ADDENDUM

PROJECT:	La Vista City Centre South MU – Lot 15	**PROJECT NO.:**	F16132
TO:	Prospective Bidders	**DATE:**	05/04/2017
FROM:	BVH Architecture	**ADDENDUM NO.:**	#2

1 FIFTH FLOOR - SPECIAL SYSTEMS

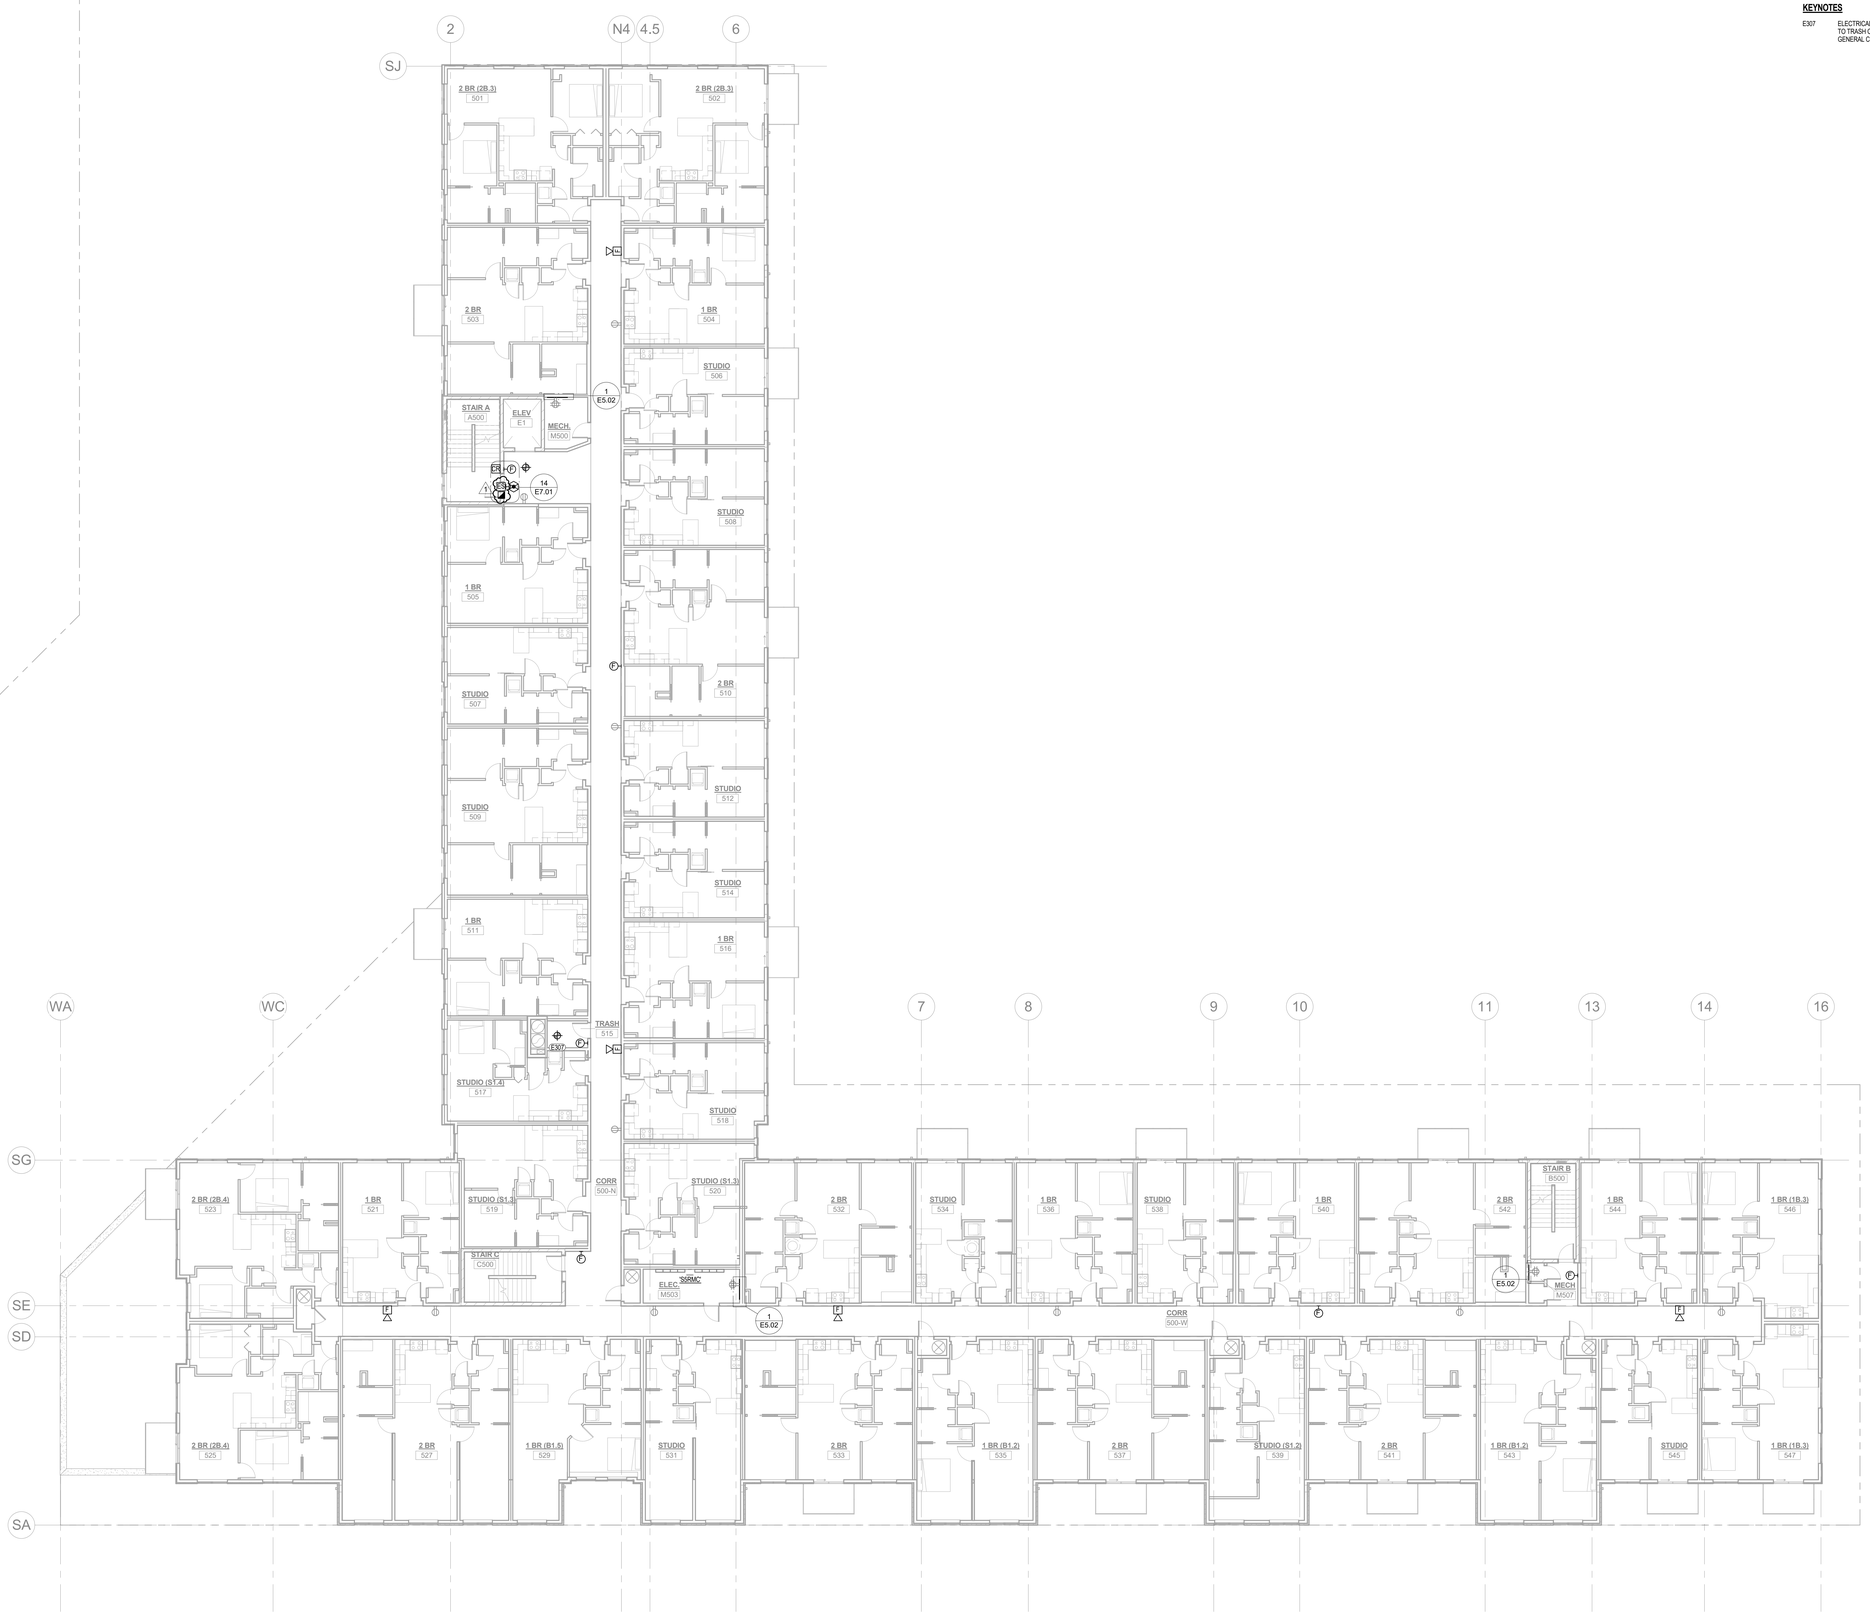
6. Sheet E3.05 – Fifth Floor – Special Systems
    a. Door A500 – Revise power transfer hinge to electric strike.

1 SIXTH FLOOR - SPECIAL SYSTEMS

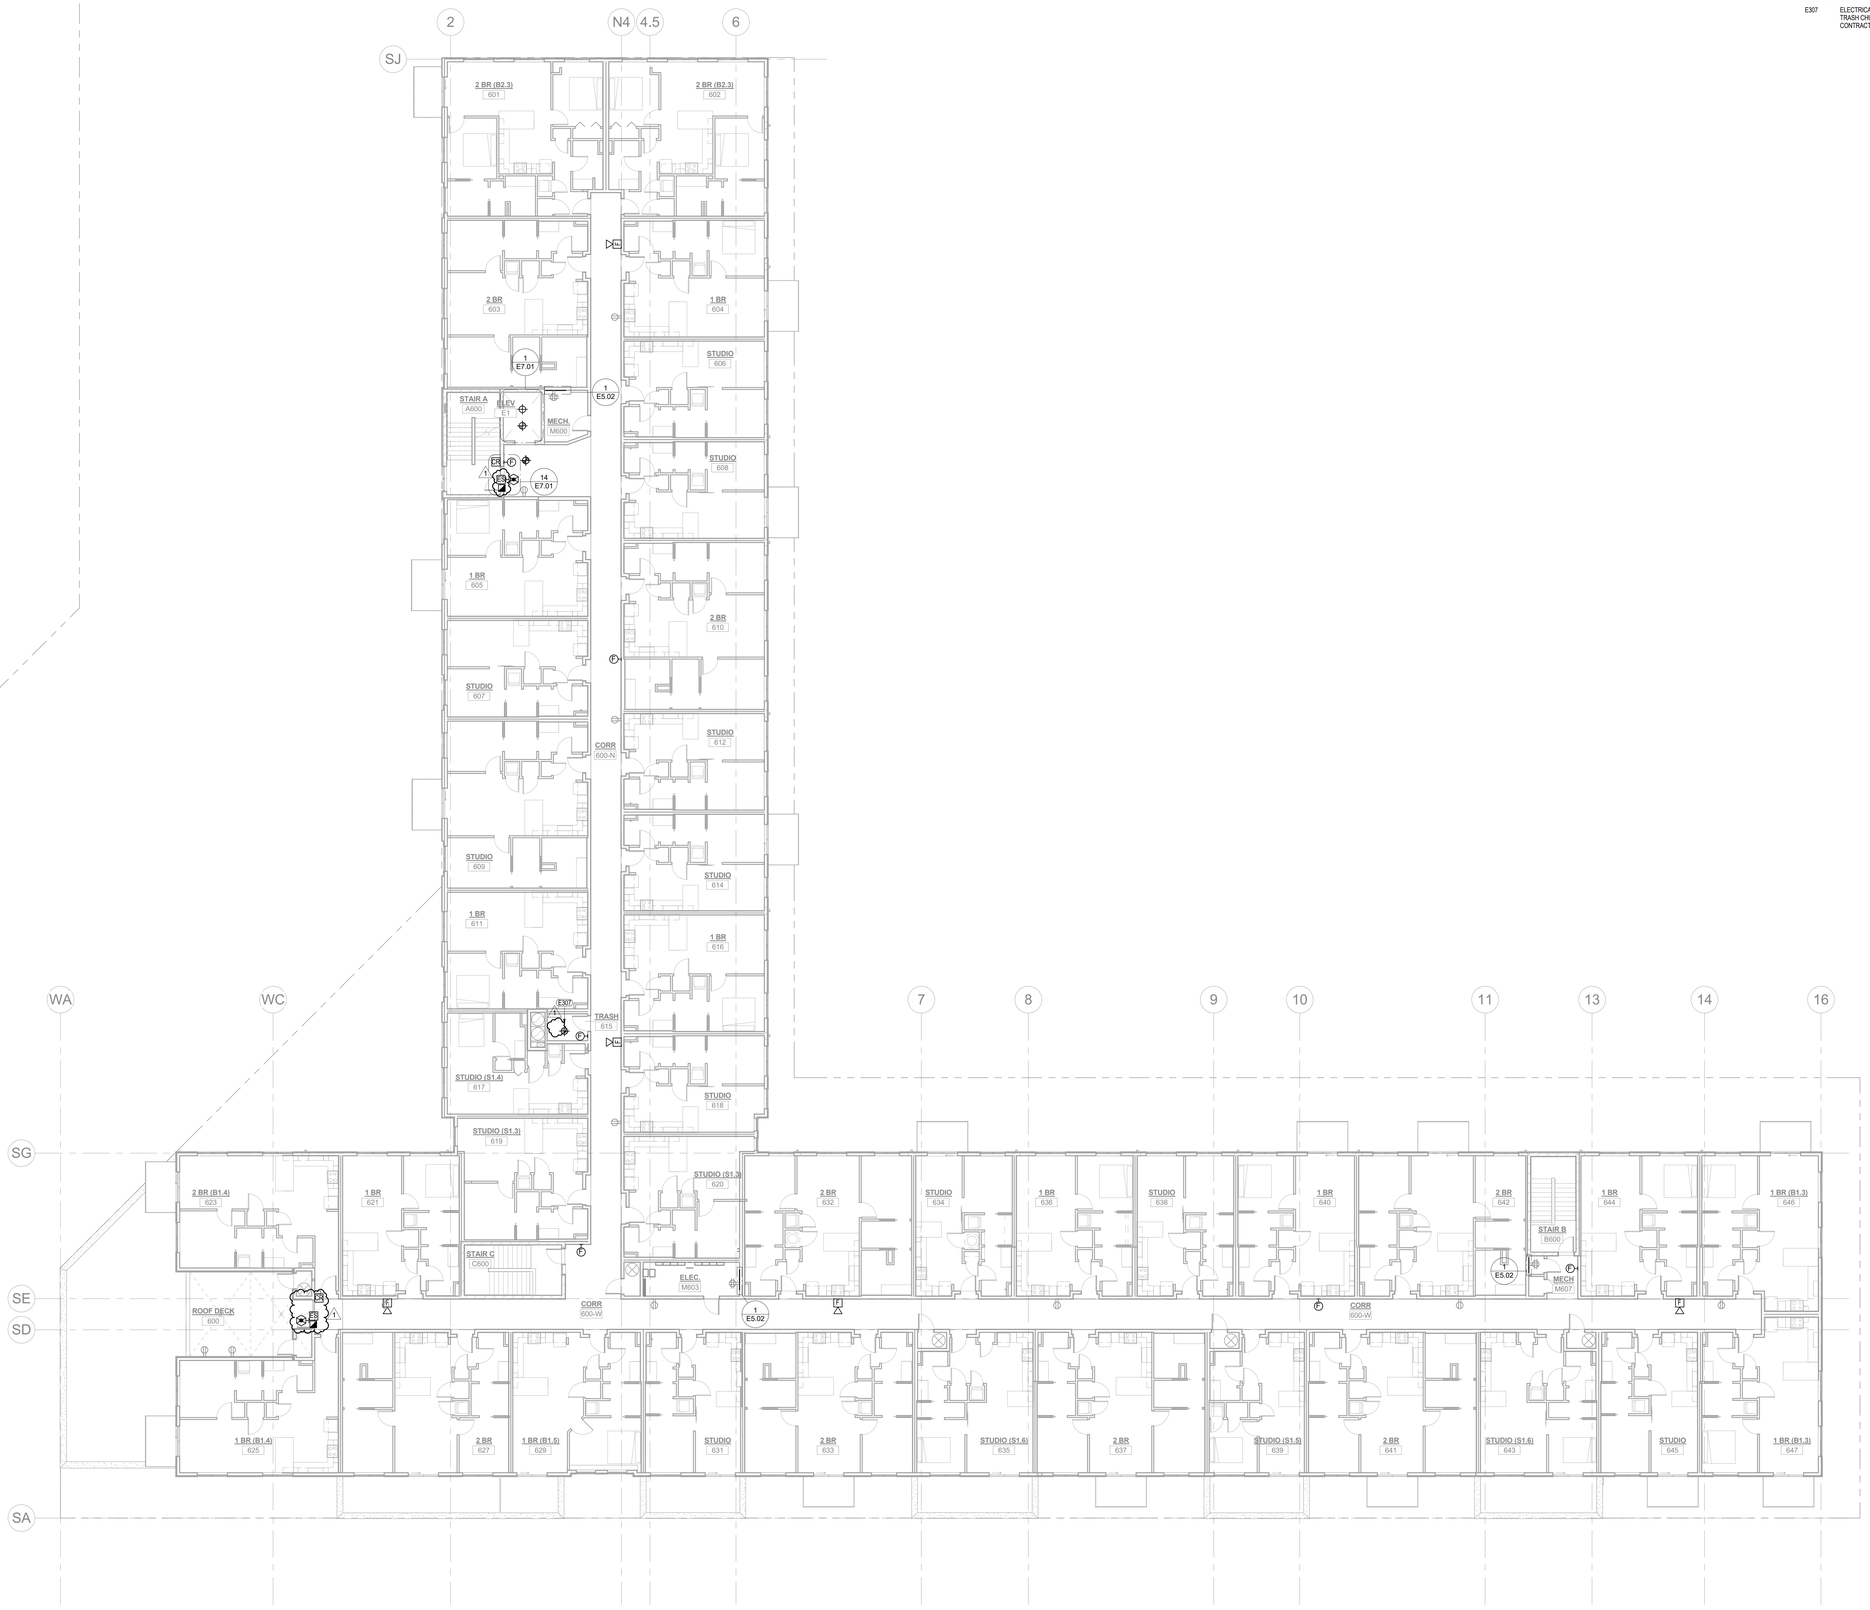
7. Sheet E3.06 – Sixth Floor – Special Systems
    a. Door A600 – Revise power transfer hinge to electric strike.
    b. Door 600 – Add card access rough-ins.
    c. Trash 615 – Remove duplicate smoke detector.
